## RESPONSE TO COMMENTS ON CRYSTAL RIVER UNIT 3 UPRATE PROJECT SITE CERTIFICATION APPLICATION

August 2007

Progress Energy Florida is pleased to provide you four electronic and four hard copies of the Response to Determination of Incompleteness for the Progress Energy Florida – Site Certification Application (SCA) for the Crystal River Unit 3 (CR3) Uprate Project.

**FIGURE 1**  
**Average Intake Monthly Temperatures**  
**(Pre and Post-Uprate Conditions)**

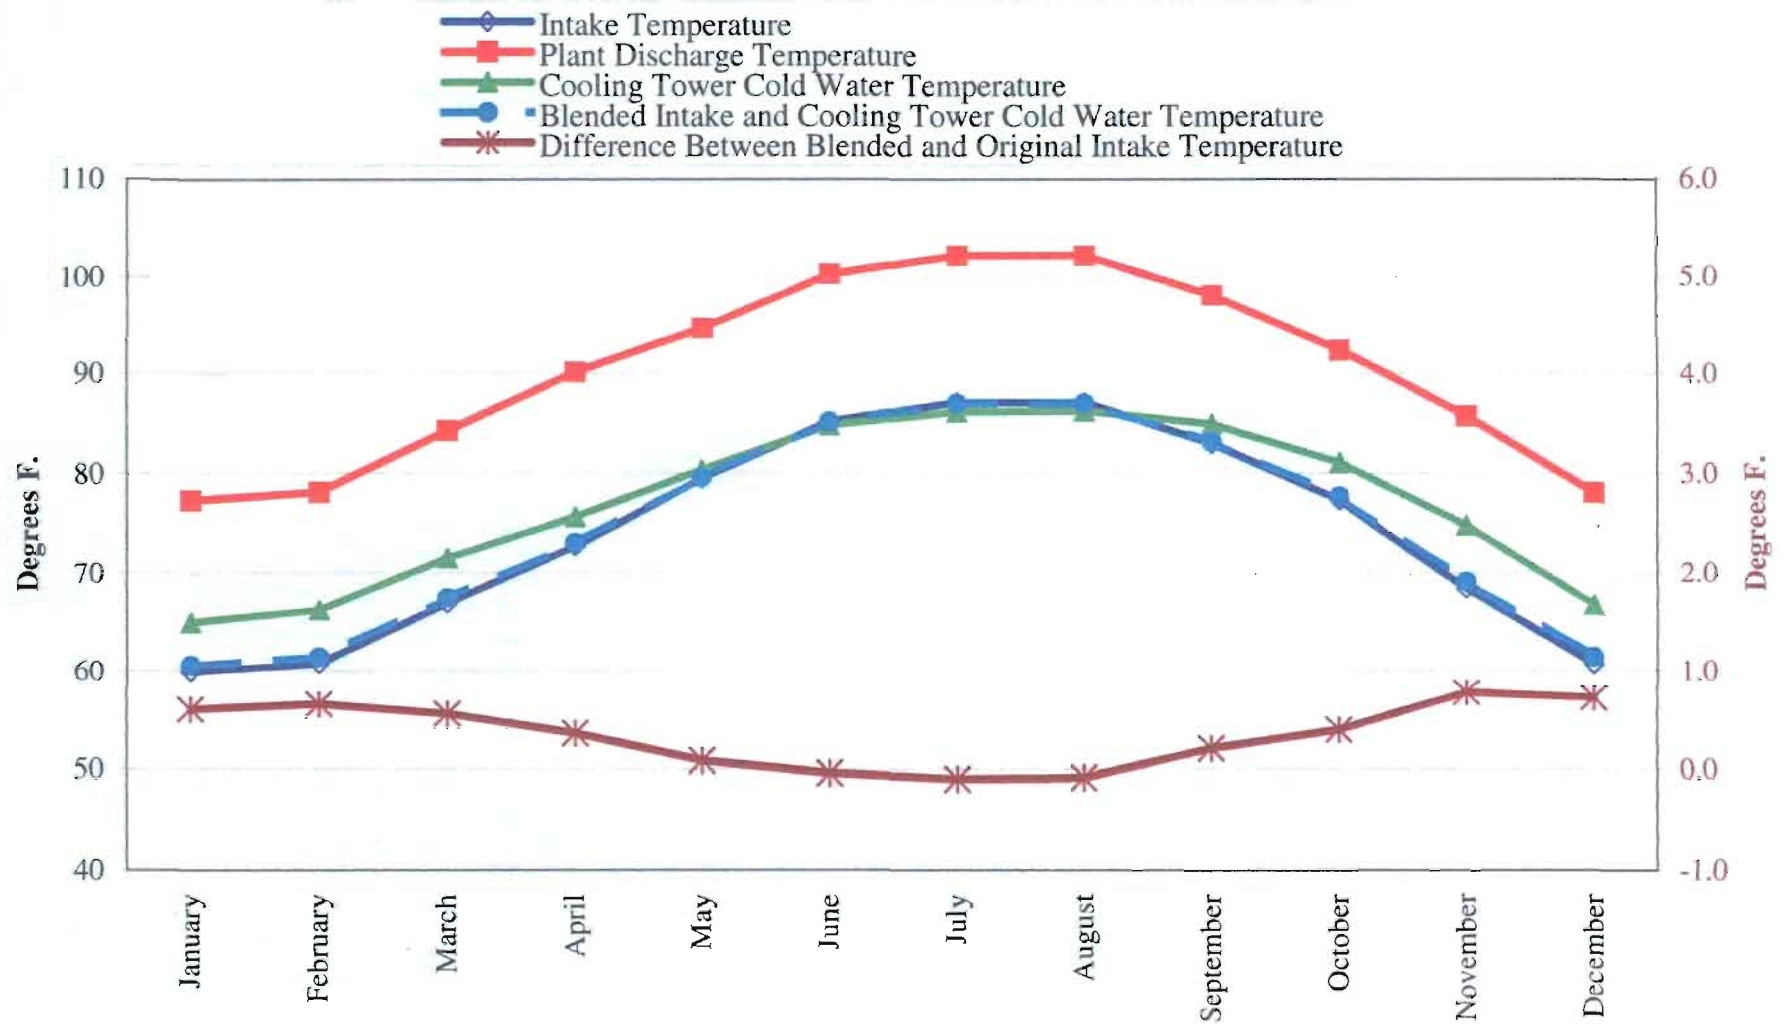
**12. The applicant has stated that there will be no net increase in thermal effluent into the Crystal Bay estuary. Please provide supporting information to substantiate this claim.**

shows the future SCT cold water temperature which will be recirculated to the intake canal, and the resulting blended temperature of the SCT's recirculating cells combined with the intake water. It shows that in no case does the SCT cooling tower discharge to the intake canal cause the three Units' intake temperature to increase by as much as one degree F. In fact, during summer months of July and August, the cooling tower cold water is predicted to actually reduce the Units' intake temperature slightly. Figure 1 displays the results of Table 1 graphically.

**FIGURE 7**  
**Pre-Uprate Circulating Water Flow Rates**

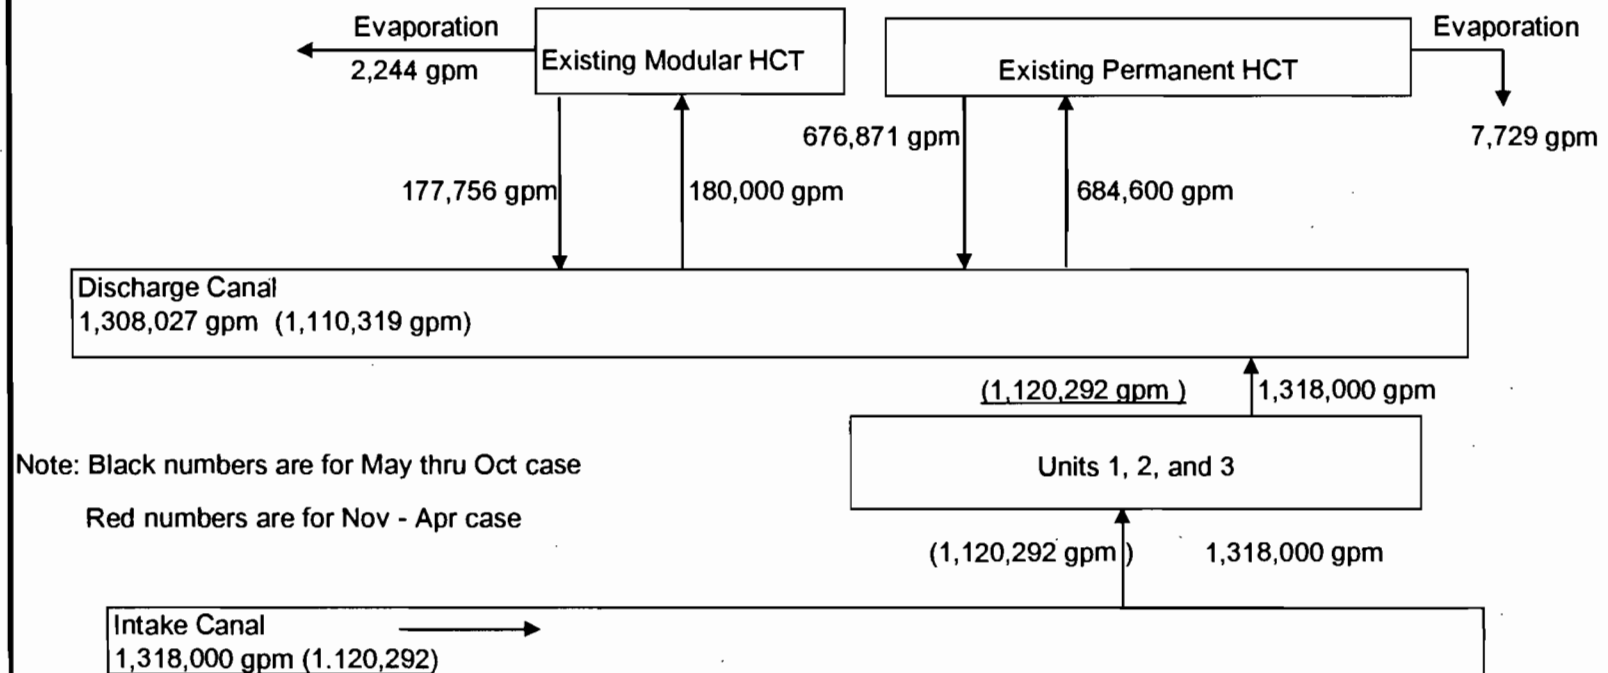
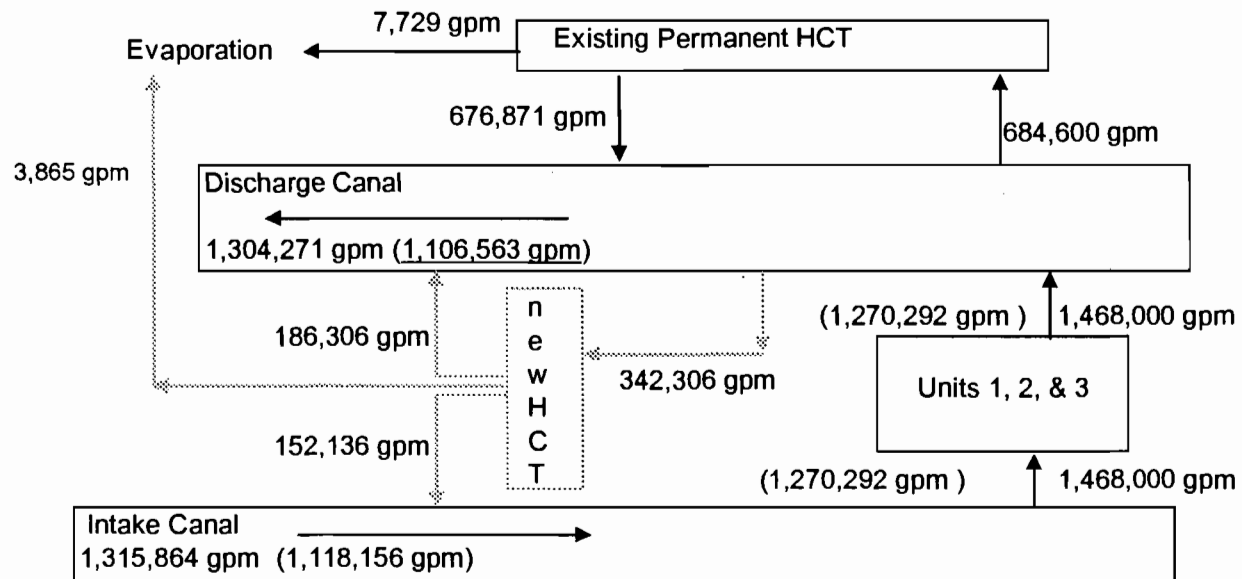
11. **Progress Energy has stated that the amount of water proposed to be withdrawn from Crystal Bay will be the same volume as currently utilized by the existing infrastructure. They have made assertion that there will be no increase of water withdrawn from Crystal Bay estuary due to facility upgrades and use of new improved technologies. Please provide supporting information to substantiate this claim.**

Figure FDEPSW-11-1 (attached) shows the flow diagrams for the pre-uprate and post-uprate

cases. The existing NPDES permit limits the flow through the three units (1, 2, and 3) to 1,318,000 gpm (1,897.9 MGD) during the months May through October, and 1,132,792 gpm (1,613.2 MGD) during the months November through April. These are shown in the top diagram of Figure FDEPSW-11-1 labeled "Pre-Uprate". The existing flow from Crystal Bay to the plant is shown under the words "Intake Canal" as 1,318,000 gpm during May through October and 1,132,792 (in red) during November through April. The diagram assumes that the existing Helper Cooling Towers (HCT) are operating; however, the flow from Crystal Bay is the same whether the HCT operate or not.

The lower diagram in Figure FDEPSW-11-1 shows the estimated plant flow rates after the uprate is complete and the SCT is operational. This diagram assumes the largest potential increase in the circulating water flow rate of 150,000 gpm resulting in flow through the three units of 1,468,000 gpm during the months of May through October, and 1,270,292 gpm during the months of November through April. The conceptual design of the SCT requires that the southernmost 8 cells operate year-round in the recirculating mode, whenever all three units are operating, in order to avoid any increase in discharge temperature or heat rejected to Crystal Bay, and to avoid any increase in flow withdrawn from Crystal Bay. In the Post-Uprate diagram shown in Figure FDEPSW-11-1, it has been assumed that the remaining 10 cells will be operating in the helper cooling tower mode in order to continue to meet the NPDES limits on rolling average discharge canal exit temperature. The 152,136 gpm that is recirculated from the new SCT 1 will be discharged to the intake canal via a diffuser to ensure that it is well-mixed with the incoming flow from Crystal Bay. As shown on the diagram, this recirculation of 152,136 gpm will reduce the amount of water withdrawn from Crystal Bay to 1,315,864 gpm during May through October, and to 1,118,156 gpm during November through April. Both of these withdrawals are reduced from the pre-uprate case and comply with the existing permit limits.

TITLE: 2009 Build Traffic Volumes

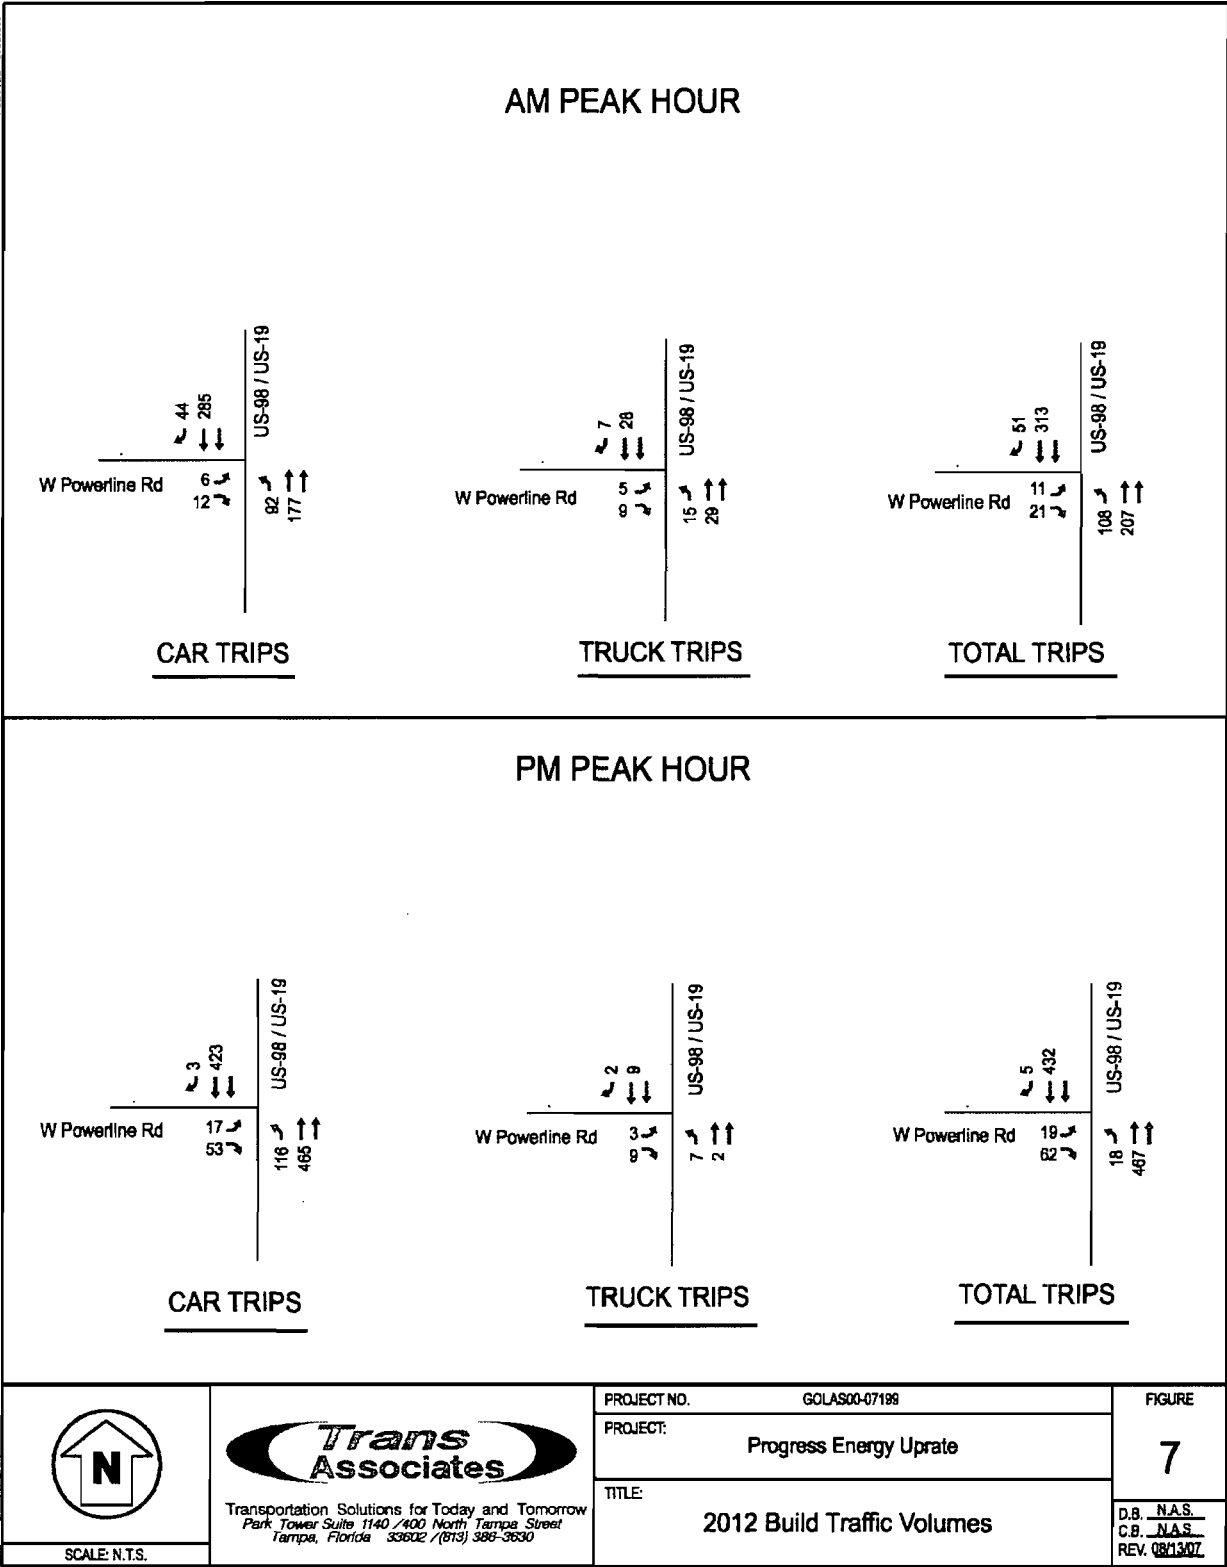
**4b. There are discrepancies in the volume data which need to be clarified. For example, Table 4.6.2-1 indicates that peak hour project volume on U.S. 19 will be 655; however, Figure 4.6.2-1 indicates there will be 966 northbound left turns and another 461 southbound right turns at the intersection of Power Line Road and U.S. 19.**

The volume of 966 northbound left turns and 461 southbound right turns from Figure 6 reflect a 2009 temporary, total traffic condition.
